TRIP REPORT

Location: James A. FitzPatrick Nuclear
Power Plant
Oswego, New York

Title: Radiological Effluent
Technical Specifications

Liquid Effluent Release Paths
James A. FitzPatrick Nuclear Power Plant

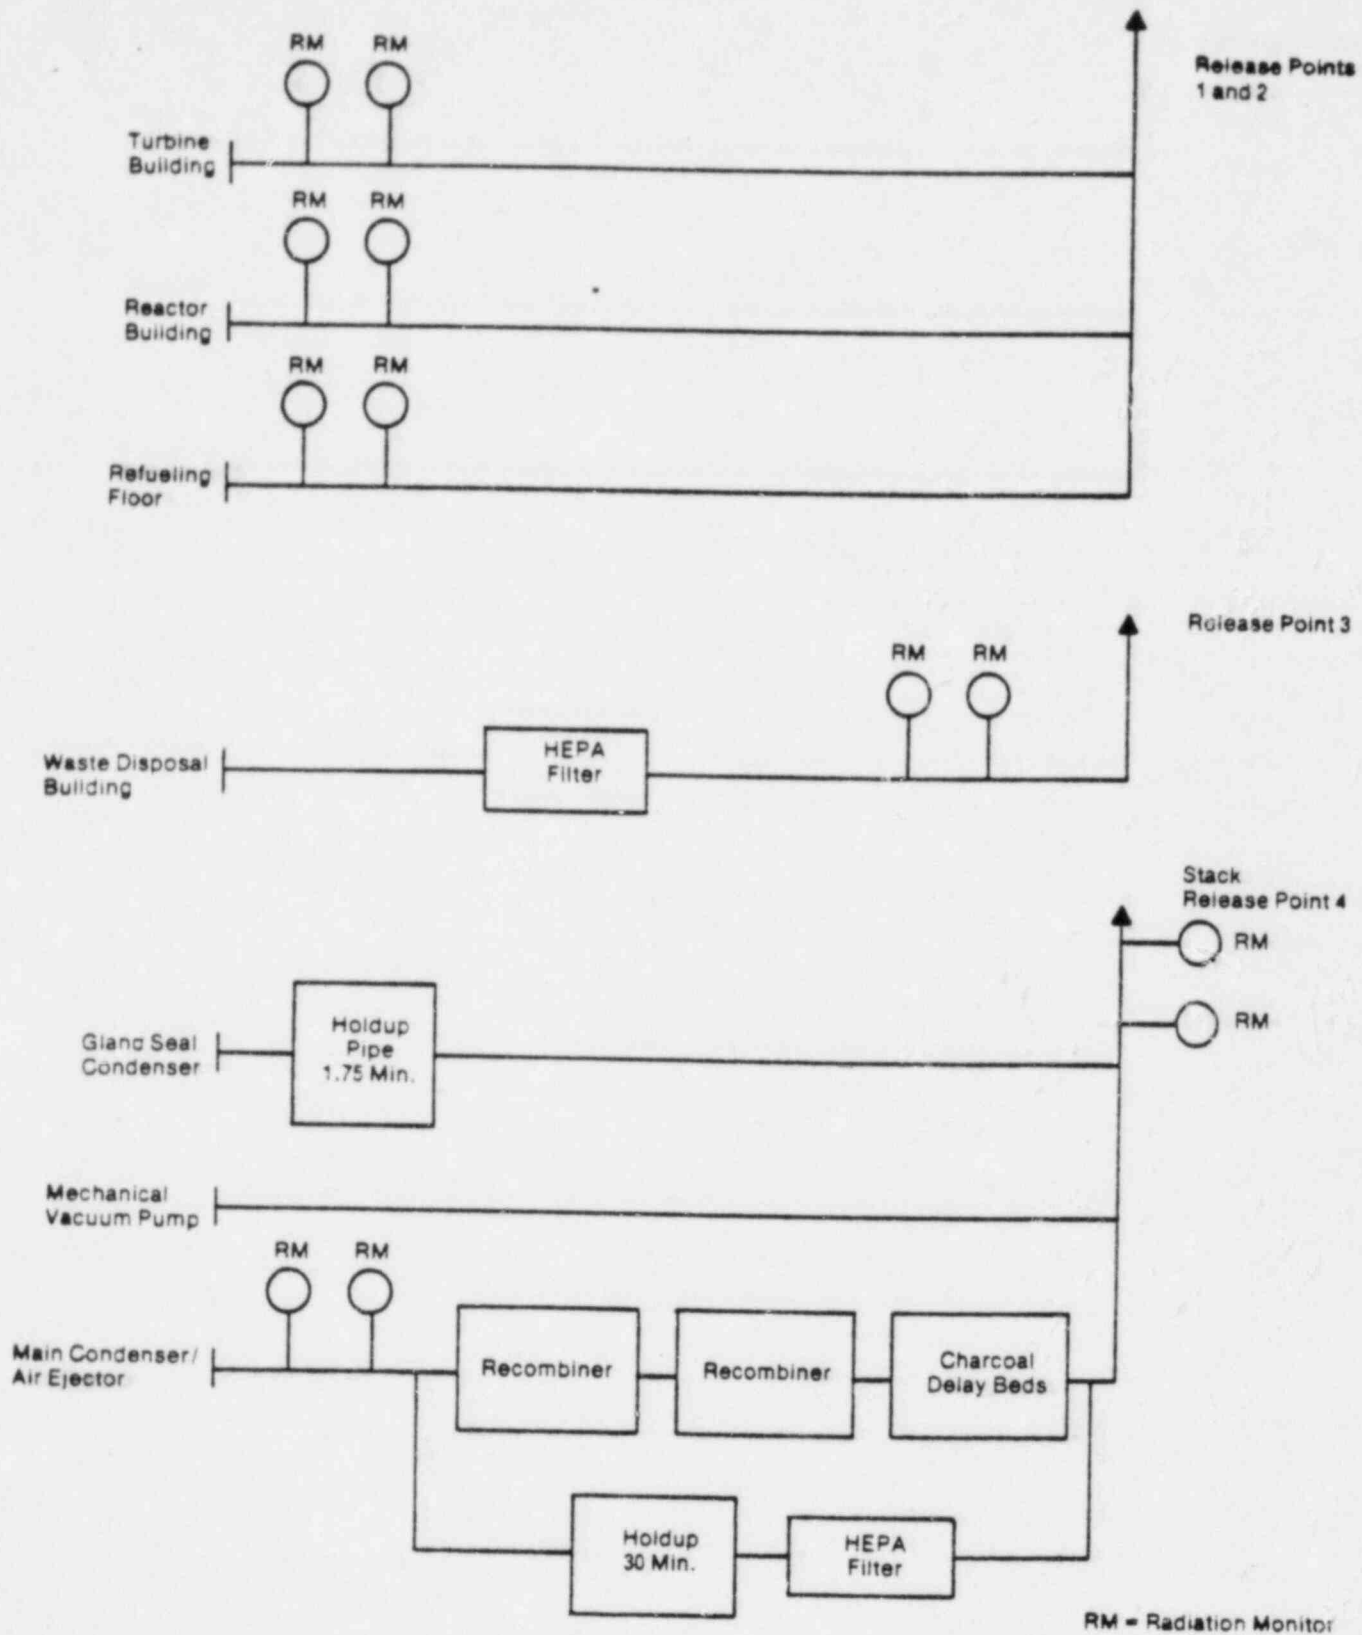
Early in the meeting, FRC reviewed with the Licensee flow diagrams of the liquid and gaseous effluent release paths in order to establish a basis for the review of the effluent monitoring instrumentation. The initial diagrams presented by FRC were prepared using information contained in "Demonstration of Compliance with 10 CFR Part 50, Appendix I, James A. FitzPatrick Nuclear Power Plant, June 4, 1976. New flow diagrams which reflect the current effluent release paths have been prepared and are included on pages 6 and 7.
